# **Office of the Inspector General**

## **Statutorily Mandated Reviews of Central Artery/Tunnel Project Building Construction Contracts 1997-1999**

**Robert A. Cerasoli  
Inspector General  
December 1999**

*Final Design drawing prepared by the Section Design Consultant for the D007C – 190 - East Boston Toll Plaza and Facilities contract.*

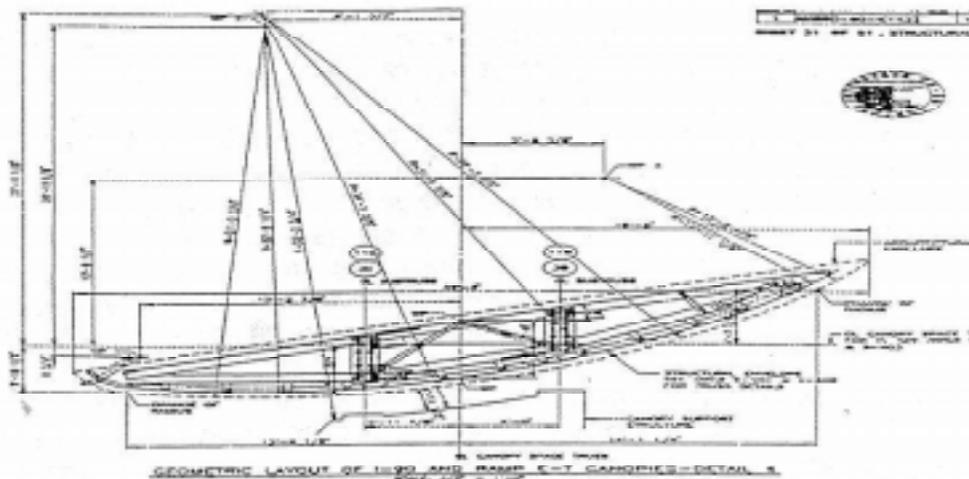
- 3) **Toll Plaza Canopy Cost:** We are particularly concerned by the cost of the toll plaza canopies, one element of the toll plaza design. In a November 1994 letter to the Project, this Office questioned the design and anticipated cost of the canopies. These canopies have a distinct design, not ordinarily seen for

toll canopies or roofs, because of aesthetic considerations.<sup>4</sup> This Office believes that more money than necessary will be spent on these canopies. The Project has estimated that the toll facility will cost about \$10 million. Staff from this Office calculate that at least 20 percent or \$2 million of the total cost will be spent to construct these canopies. The canopy design is complex, involving multiple curves in the steel structure. The complexity of the design means higher construction costs and may be responsible for a large number of future change orders once construction begins.

In our opinion, more money than necessary will be spent on these canopies; simpler canopies could have been designed for savings of between \$250,000 and \$750,000. We do not question the importance of aesthetic considerations; nevertheless, a lack of adequate design review and the creation of a unique canopy design contributed to unnecessarily high costs.

<sup>4</sup> The canopy is metal and is designed like an airplane wing with various complex curves. This design is not normally used for a roof structure. The design appears to have been selected on the basis of aesthetic considerations, since it serves no basic structural function. According to a November 1994 letter from the Project to this Office, "the canopy was an appropriate feature to highlight the 'gateway' to Boston through the Third Harbor Tunnel."
